Environmental Quality Commission

SPECIAL MEETING AGENDA

STAFF REPORT

Regular Business: Make a determination on an appeal for Atlas cedar heritage tree at 1810 Bay Laurel Drive

Schematic Planting Plan
07/14/2017

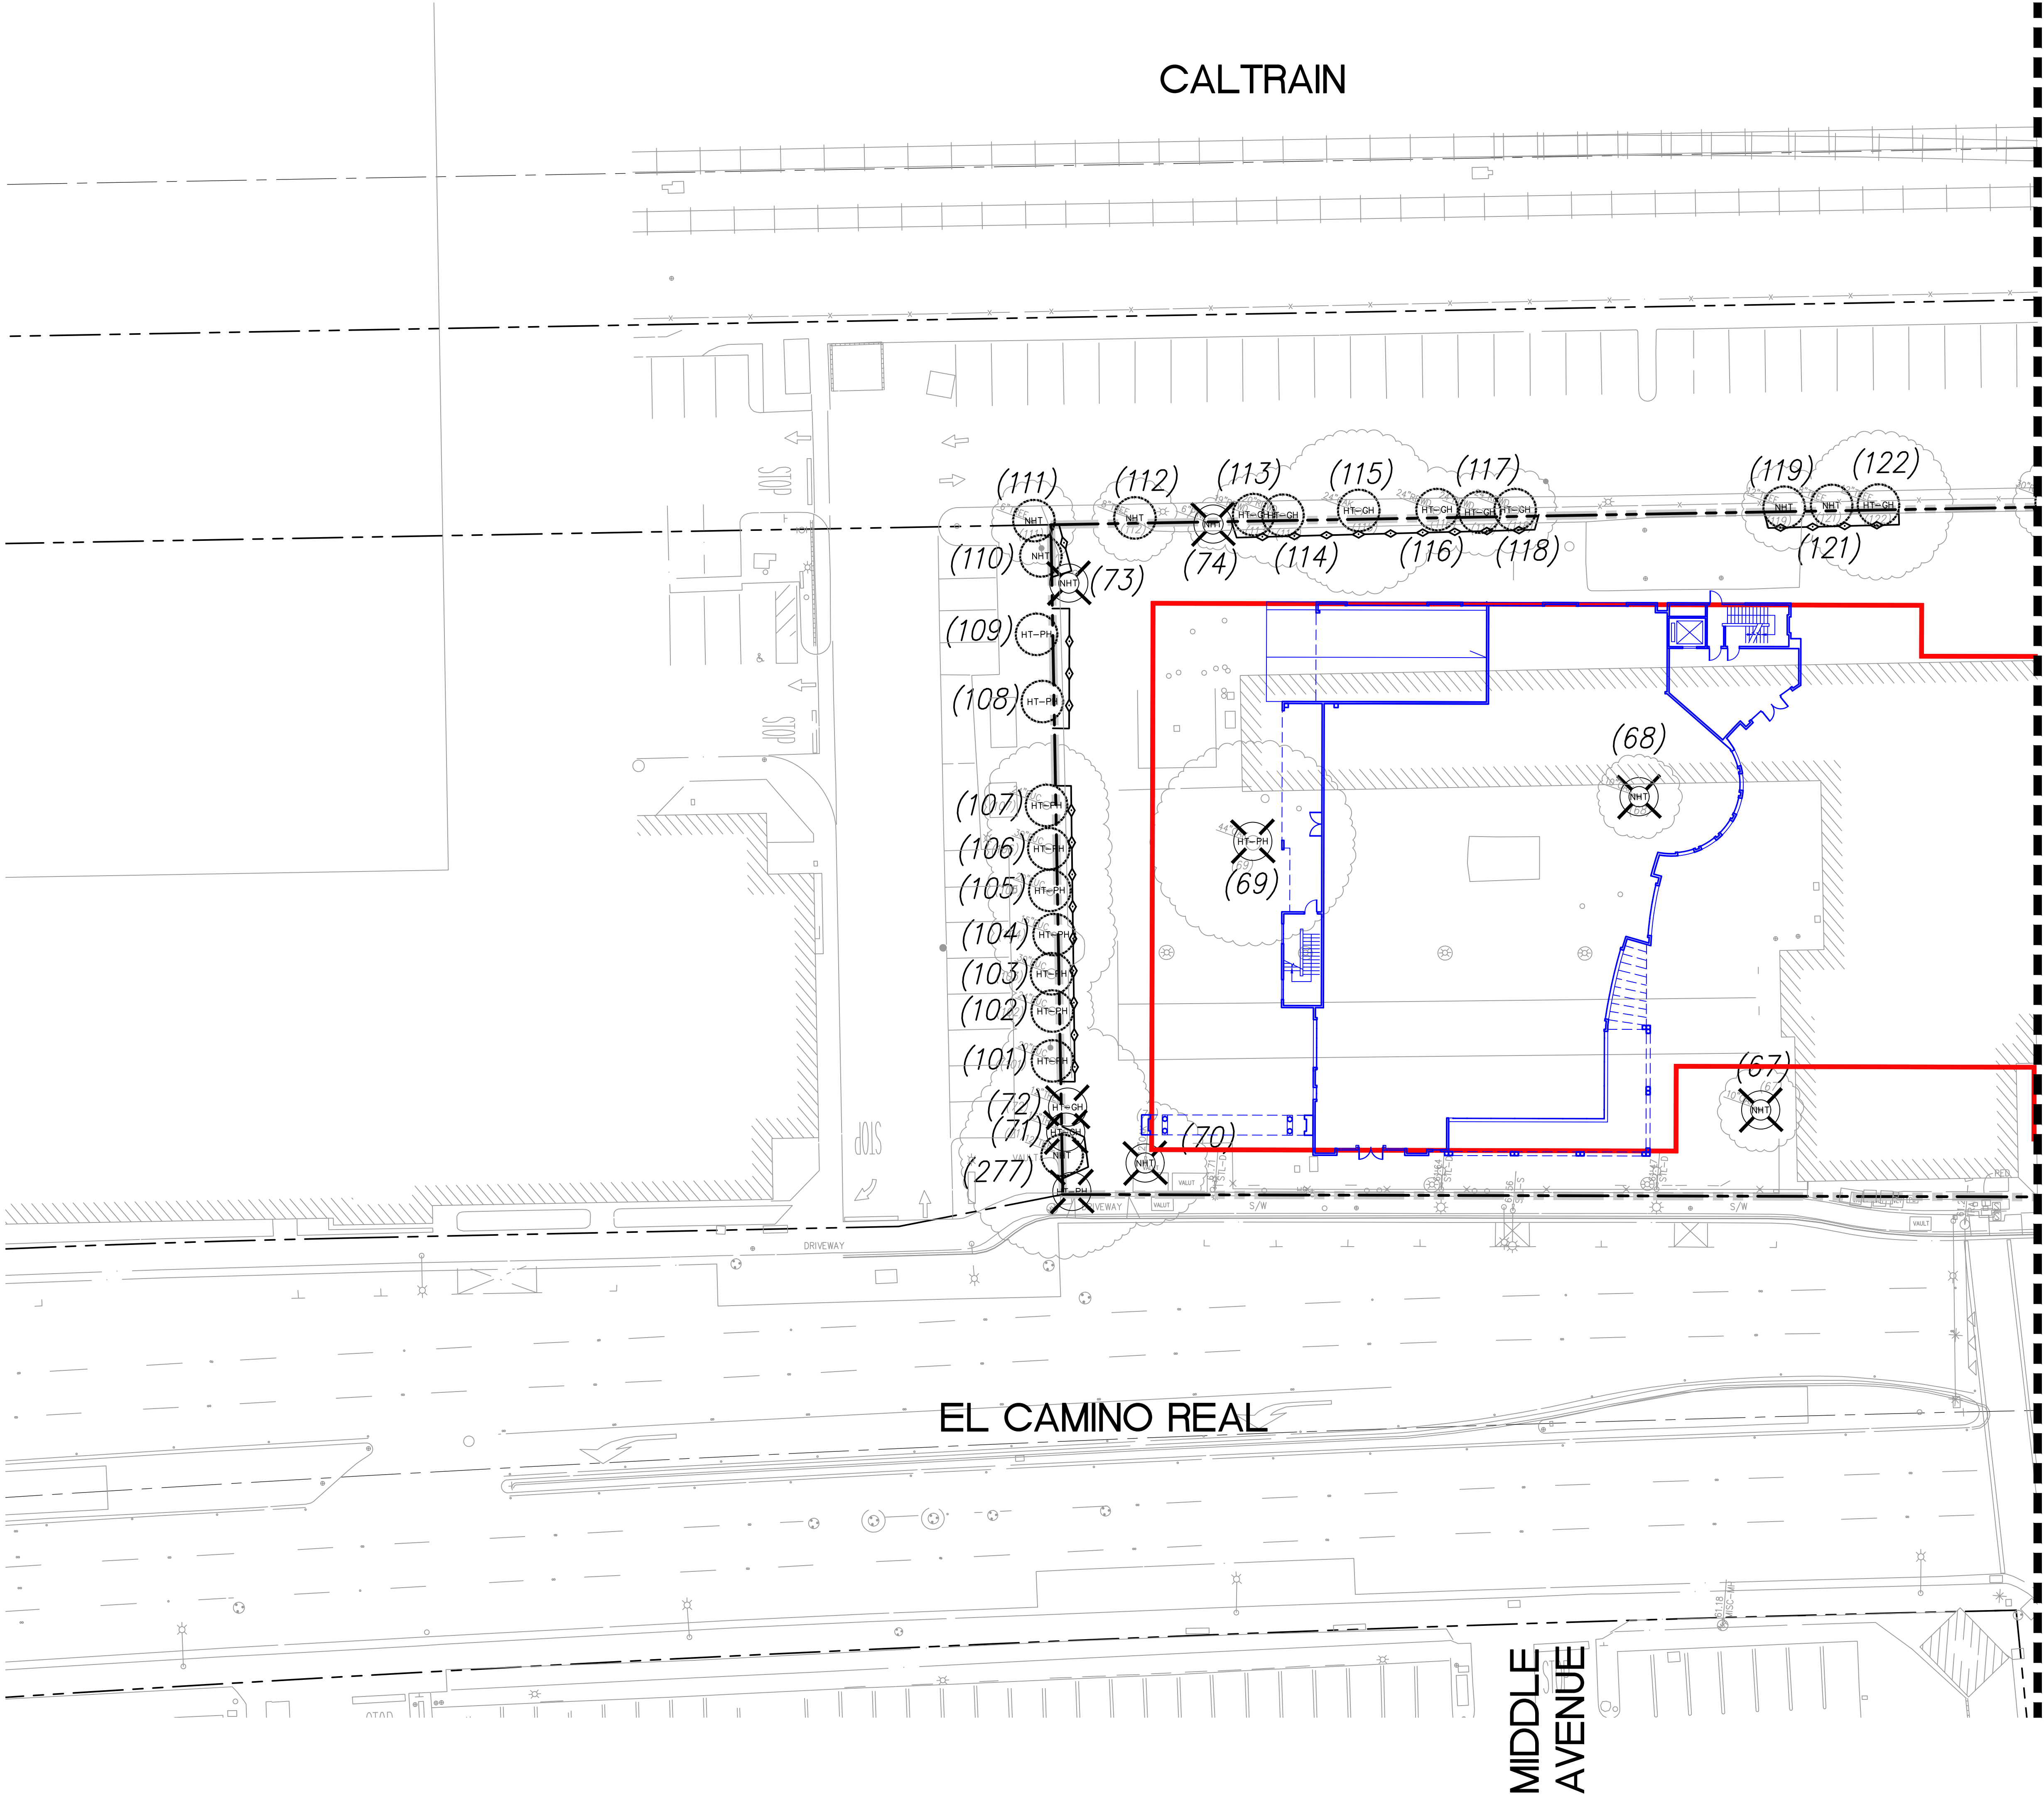
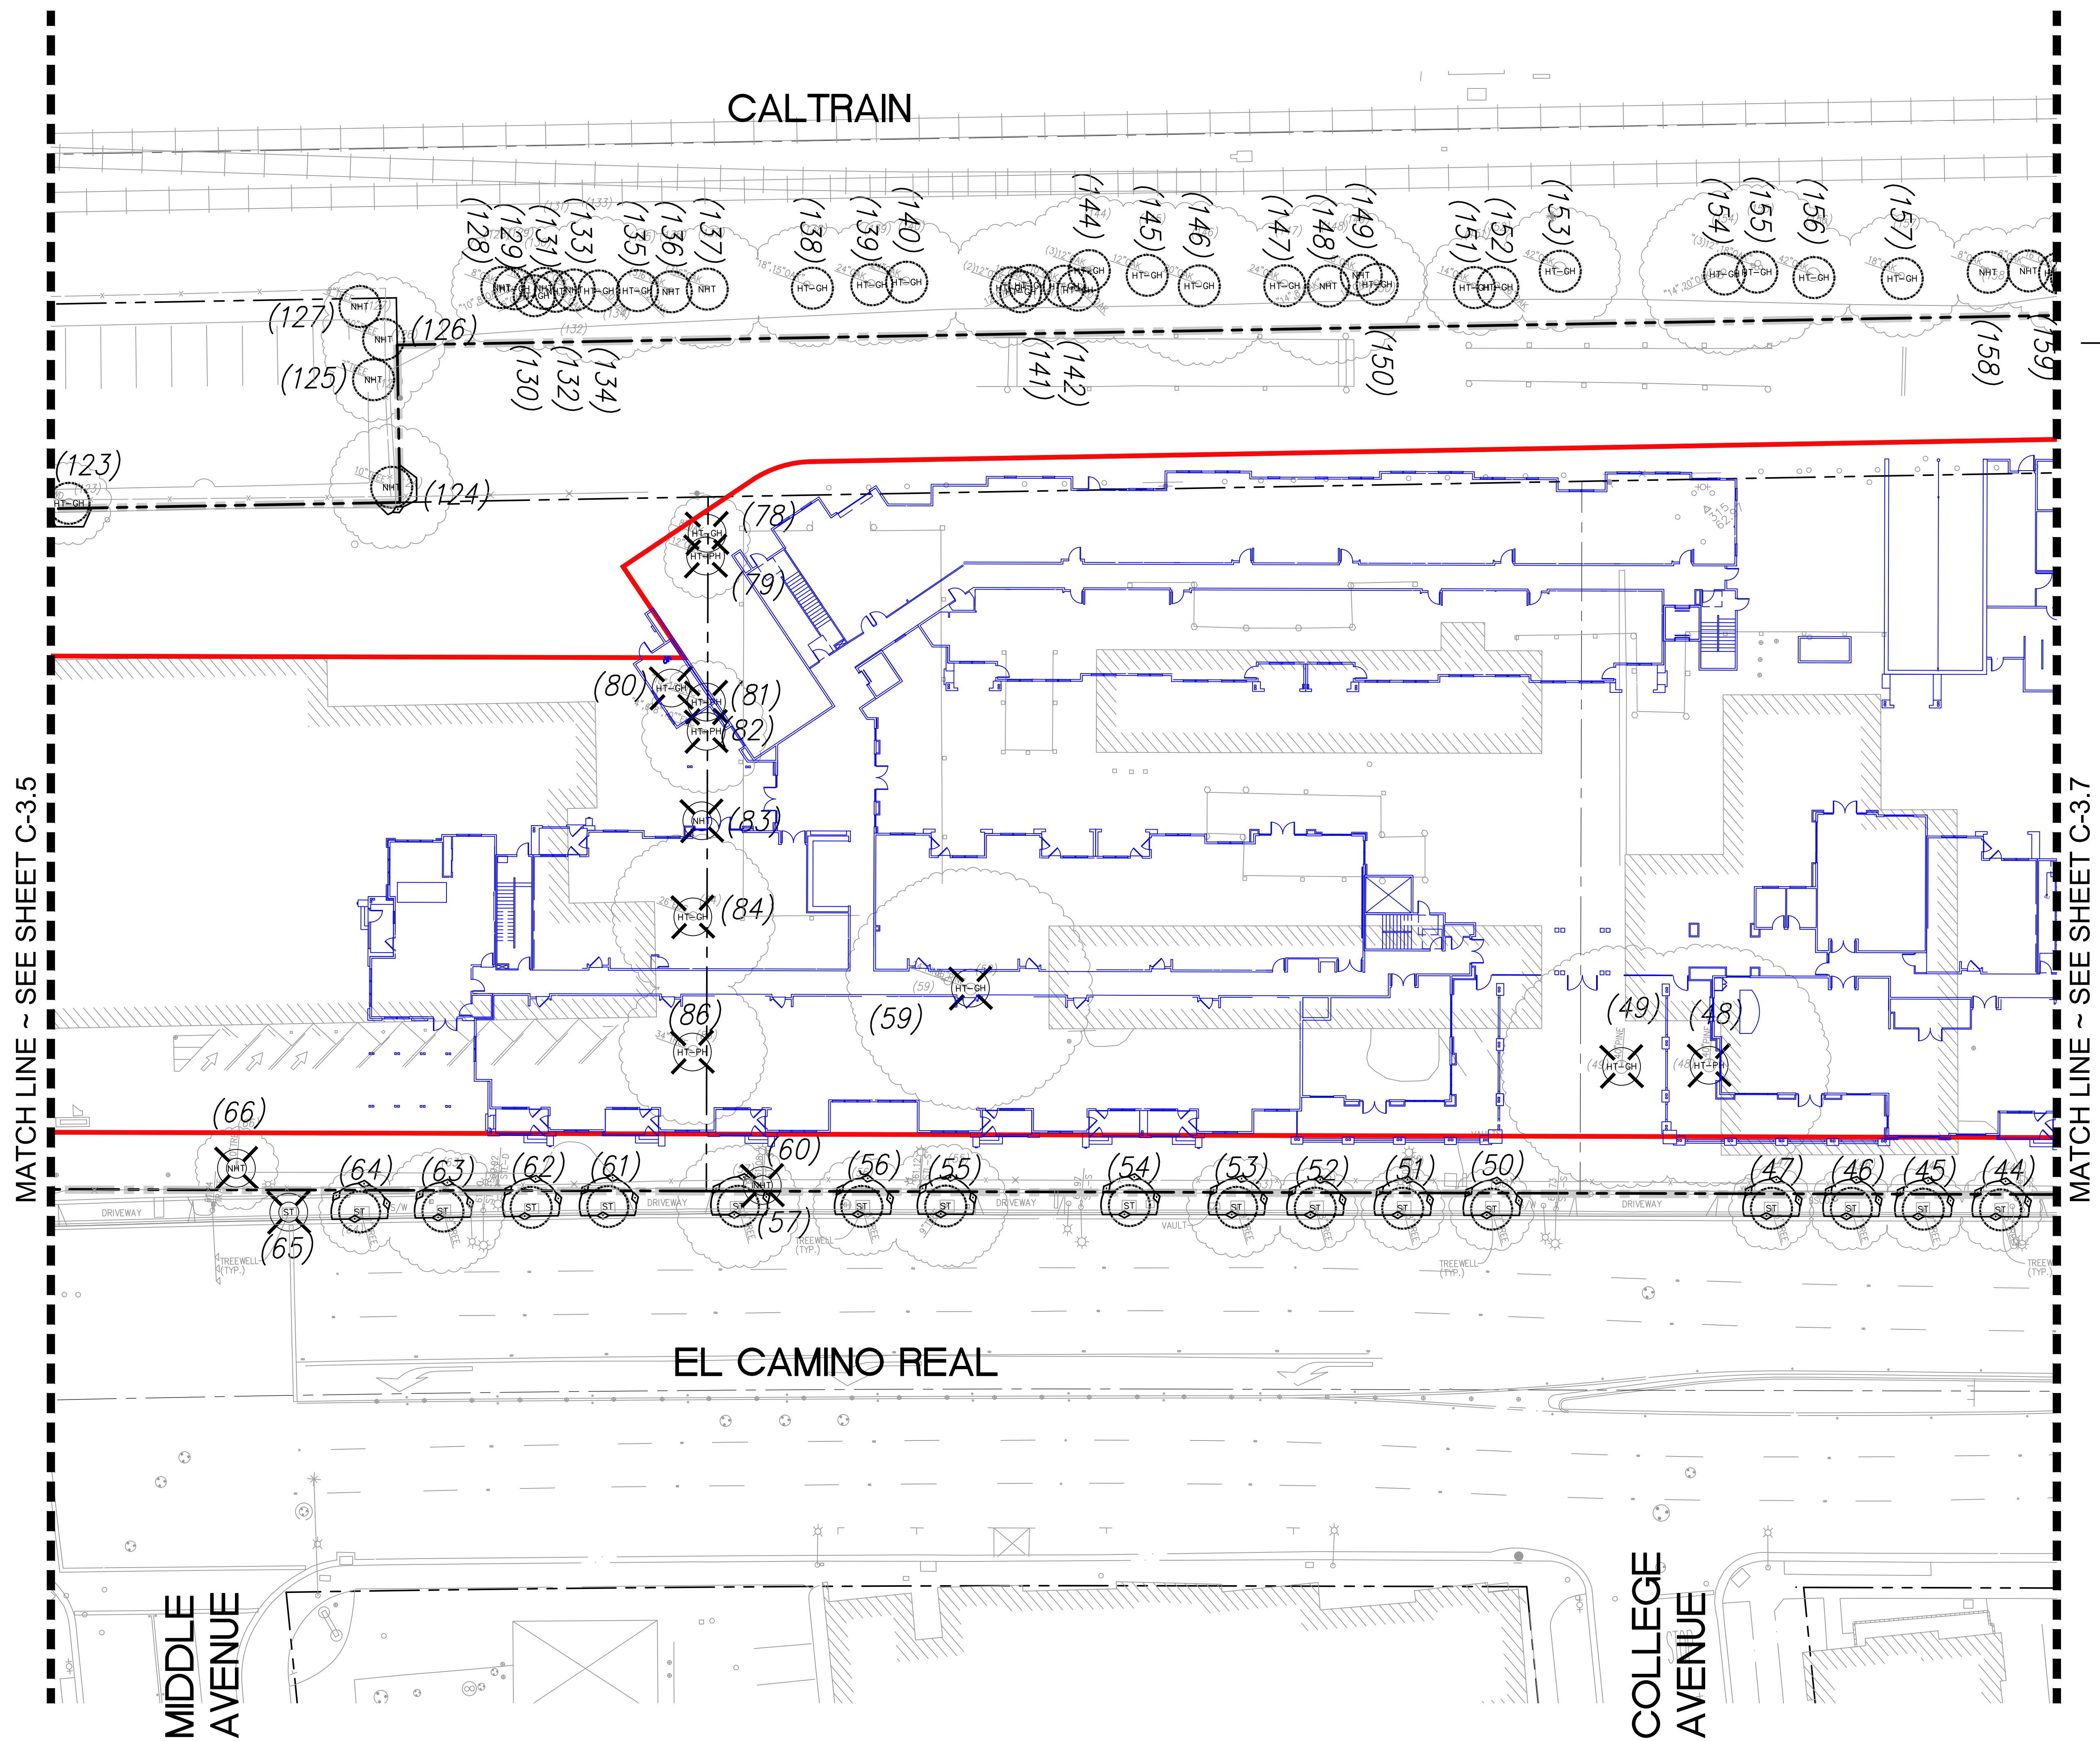
Two London plane street trees along El Camino Real (trees #23 and #24) are shown on the submitted plans as proposed for removal to accommodate a new driveway and curb improvements between the residential buildings and Office Building 2, across El Camino Real from Partridge Avenue. A third London plane street tree (tree #65) is proposed for removal for a new driveway between the plaza and the residential buildings. All three of these street trees are non-heritage in size. While tree #65 is rated as only moderately suitable for preservation by the project arborist, trees #23 and #24 are rated as highly suitable for preservation. Since submittal of the plans, the applicant has indicated that tree #23 could be retained as part of the proposed project. As discussed later in this report, staff will work with the project arborist, before the Planning Commission and City Council hearings, to identify additional street tree planting locations along El Camino Real so there is no net loss in the number of street trees.

In contrast, street trees adjacent to the project site were generally in good condition with a few individual trees in fair condition. The city arborist recommends preserving the two London plane street trees (trees #23 and #24) shown as proposed for removal on the submitted plans, or if preservation is not possible, for the project arborist to work with City staff to identify additional street tree planting locations to avoid a net loss in the number of street trees on El Camino Real. As discussed previously, since submittal of the plans, the applicant has indicated that tree #23 could be retained as part of the project. It should also be noted that the Specific Plan requires a 60-foot building break aligned with Partridge Avenue, on the west side of El Camino Real, making this an ideal location for a driveway. Staff will work with the project arborist, before the Planning Commission and City Council hearings, to identify additional street tree planting locations, either in front of the subject property or at other locations along El Camino Real, so there is no net loss in the number of street trees.
